**Subject: San Onofre Nuclear Generating Station Unit 2
Docket No. 50-361
Proposed Change Number NPF-10-540
License Amendment Request, "Reactor Coolant System (RCS)
Pressure and Temperature Limits Report (PTLR)"**

**PROPOSED CHANGE NUMBER (PCN) – 540
REMOVAL OF REACTOR COOLANT SYSTEM (RCS) PRESSURE
AND TEMPERATURE CURVES FROM THE TECHNICAL SPECIFICATIONS
TO A PRESSURE AND TEMPERATURE LIMITS REPORT (PTLR)**

**DESCRIPTION AND NO SIGNIFICANT HAZARDS ANALYSIS
FOR PROPOSED CHANGE NPF-10-540
REMOVAL OF REACTOR COOLANT SYSTEM (RCS) PRESSURE AND
TEMPERATURE CURVES FROM THE TECHNICAL SPECIFICATIONS TO A
PRESSURE AND TEMPERATURE LIMITS REPORT (PTLR)
San Onofre Nuclear Generating Station Unit 2**

Figure 3.4.3-1

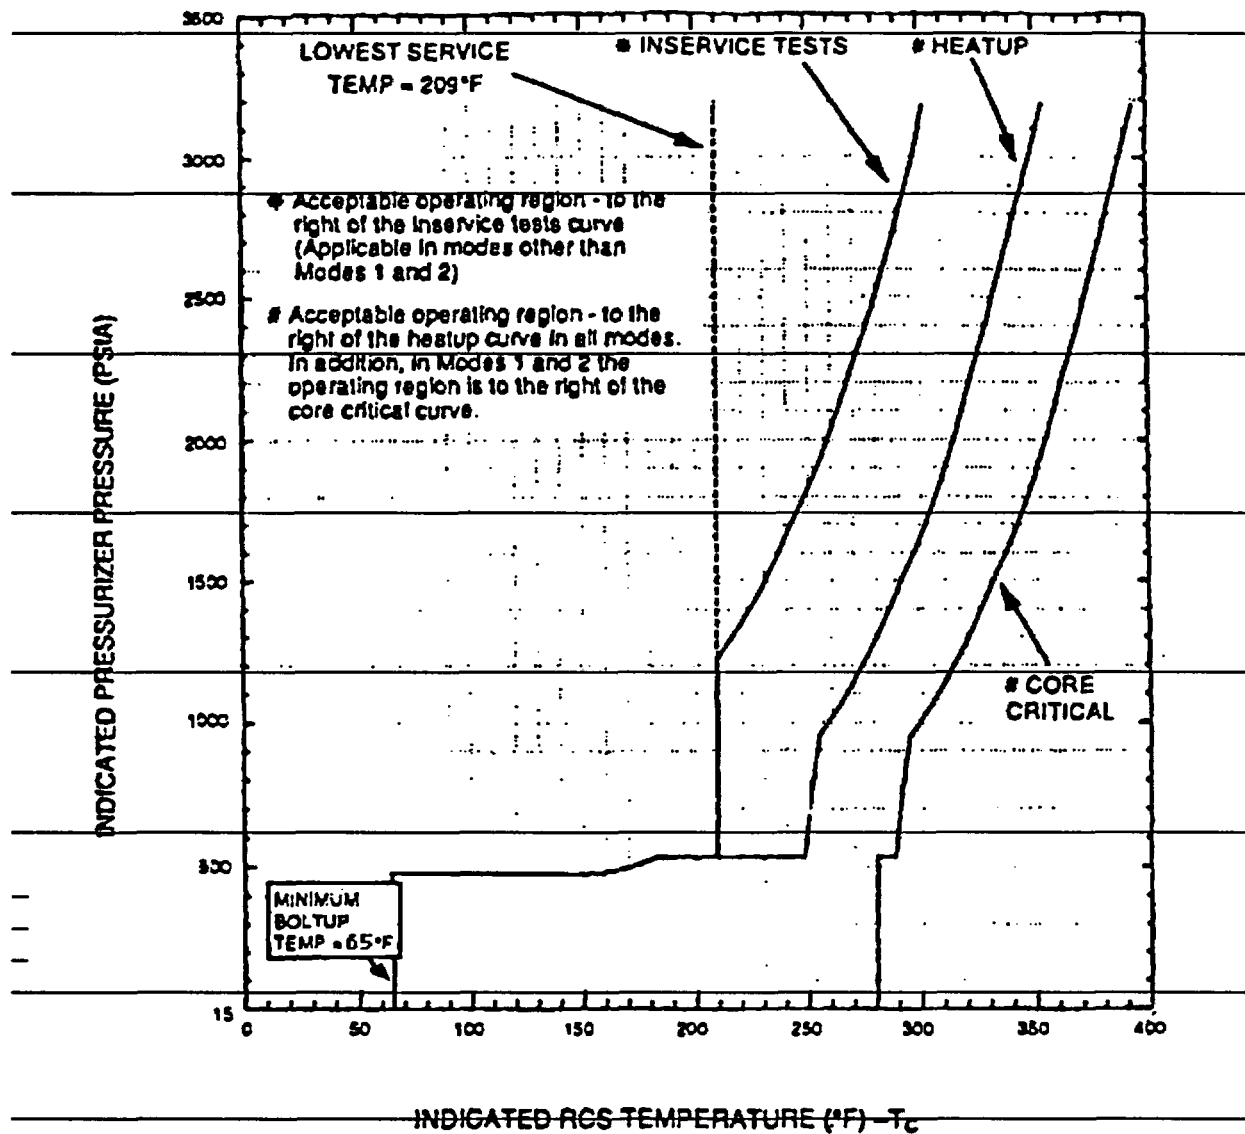
SONGS 2 HEATUP RCS PRESSURE/TEMPERATURE
LIMITATIONS UNTIL 20 EFY
Normal Operation

SIT isolation or depressurization to less than the ~~Figure 3.4.3-2~~ limit limits in the PTLR is only required when SIT pressure is greater than or equal to the maximum RCS pressure for the existing RCS cold leg temperature allowed by the PTLR/T limit curves provided in ~~Figure 3.4.3-1~~ and ~~Figure 3.4.3-2~~.

B. SIT pressure is greater than or equal to the maximum RCS pressure for existing cold leg temperature allowed in Figure 3.4.3-1 and Figure 3.4.3-2 the PTLR.	B.1 Isolate affected SIT.	1 hour

Figure 3.4.3-1
DELETED

FIGURE 3.4.3-2

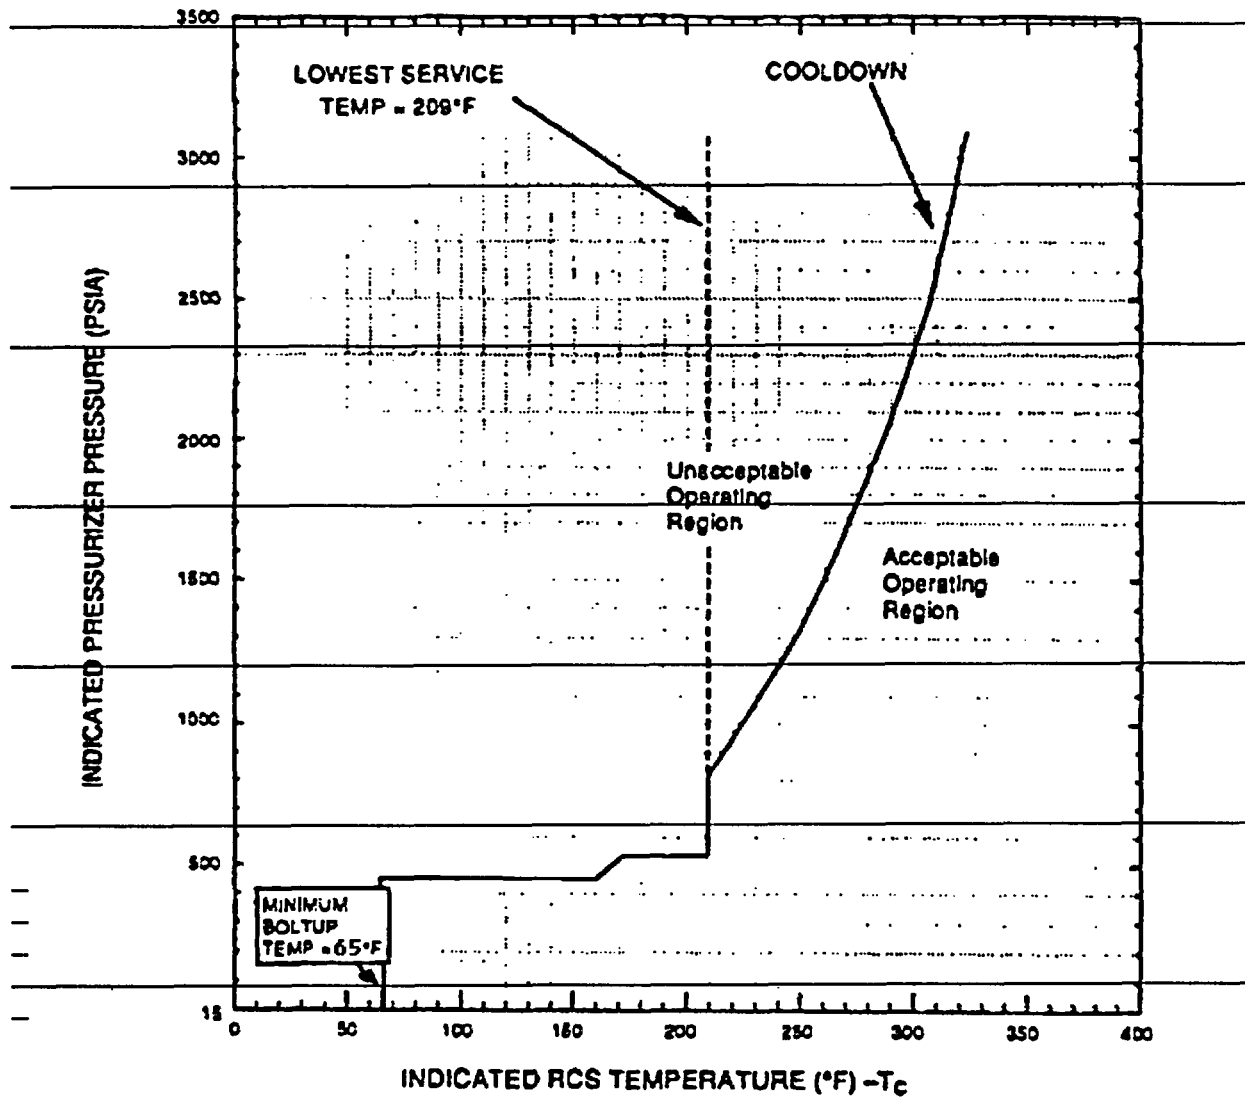
SONGS 2 COOLDOWN RCS PRESSURE/TEMPERATURE
LIMITATIONS UNTIL 20 EFY
Normal Operation

LCO 3.4.12.1 No more than two high pressure safety injection pumps shall be OPERABLE, the safety injection tanks shall be isolated or depressurized to less than the limit specified in the PTLR ~~Figure 3.4.3-2~~ and at least one of the following overpressure protection systems shall be OPERABLE:

FIGURE 3.4.3-2
DELETED

FIGURE 3.4.3-3

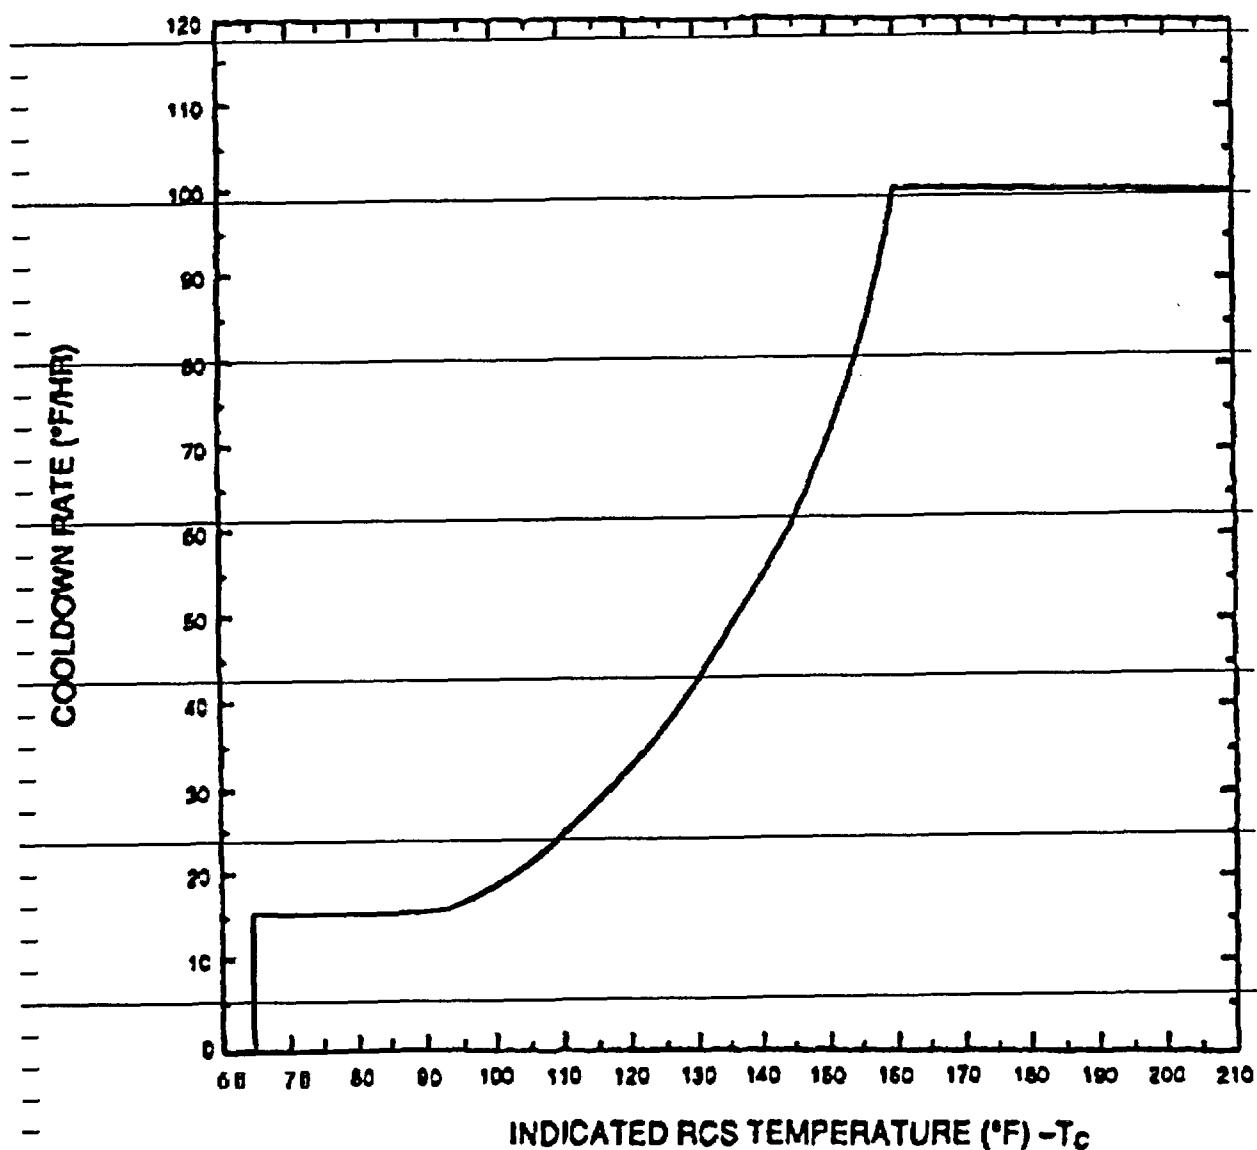
- ~~a. A maximum heatup of 60°F in any 1-hour period with RCS cold leg temperature greater than or equal to 65°F.~~
- ~~b. A maximum cooldown as specified by Figure 3.4.3-3 in any 1-hour period with RCS cold leg temperature less than or equal to 160°F. A maximum cooldown of 100°F in any 1-hour period with RCS cold leg temperature greater than 160°F.~~
- ~~c. A maximum temperature change of 10°F in any 1-hour period during inservice hydrostatic and leak testing operations above the heatup and cooldown limit curves.~~
- ~~d. A minimum temperature of 65°F to tension reactor vessel head bolts.~~

SONGS 2 RCS PRESSURE/TEMPERATURE LIMITS
MAXIMUM ALLOWABLE COOLDOWN RATES (UNTIL 20 EFY)
Normal Operation

FIGURE 3.4.3-3
DELETED

FIGURE 3.4.3-4

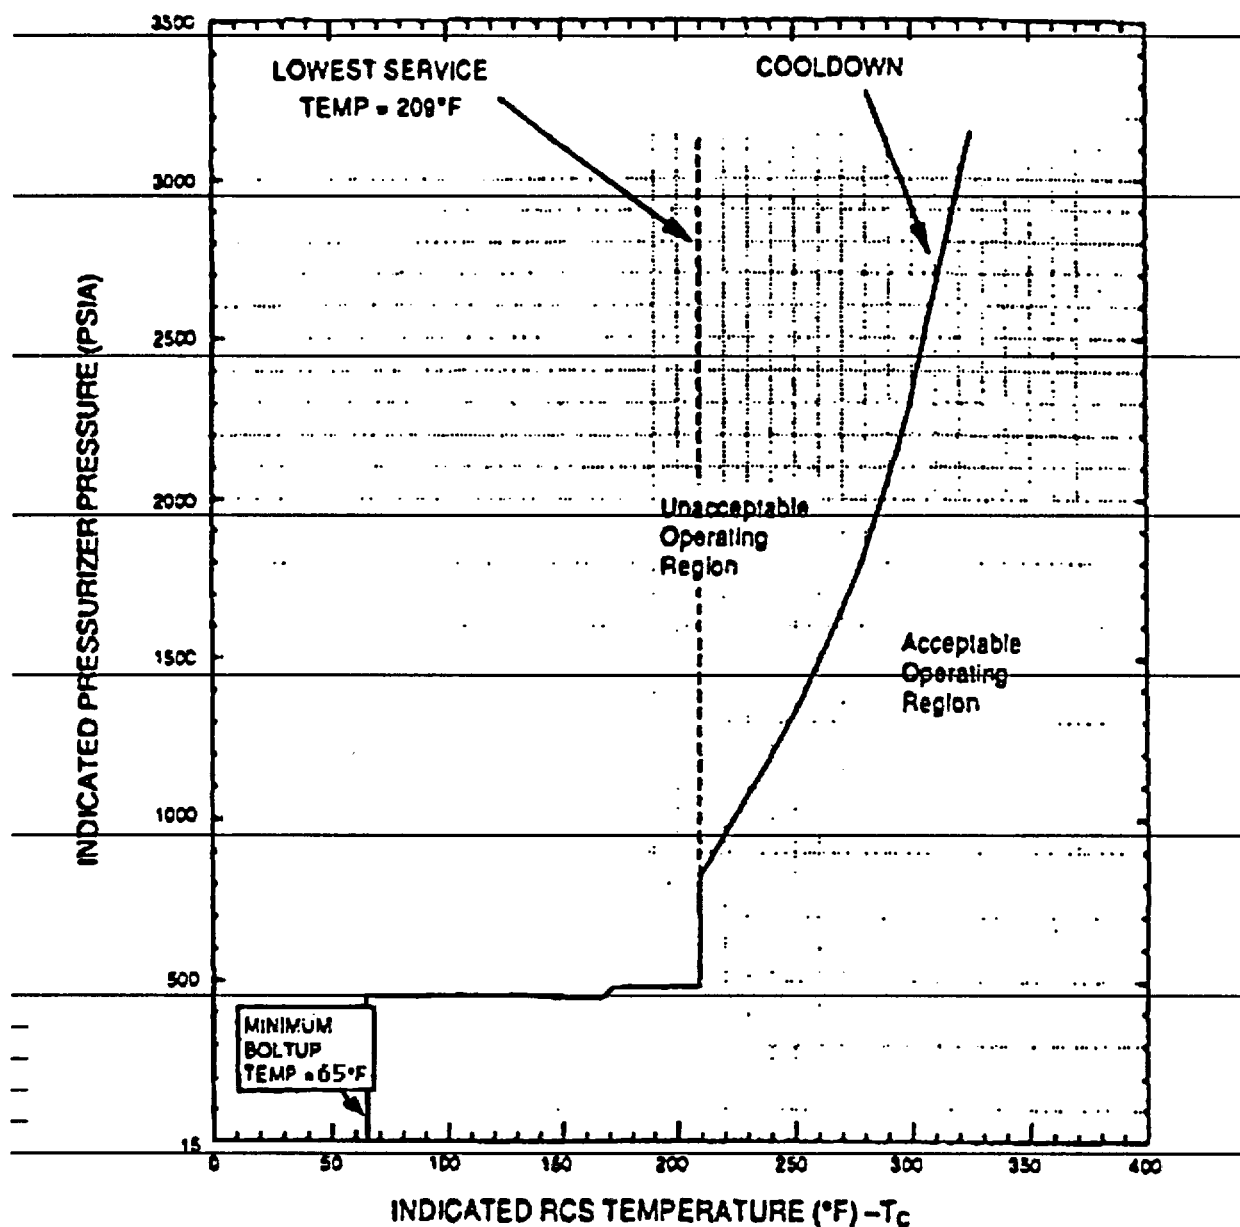
SONGS 2 COOLDOWN RCS PRESSURE/TEMPERATURE
LIMITATIONS UNTIL 20 EFY
Remote Shutdown Operation

FIGURE 3.4.3-4
DELETED
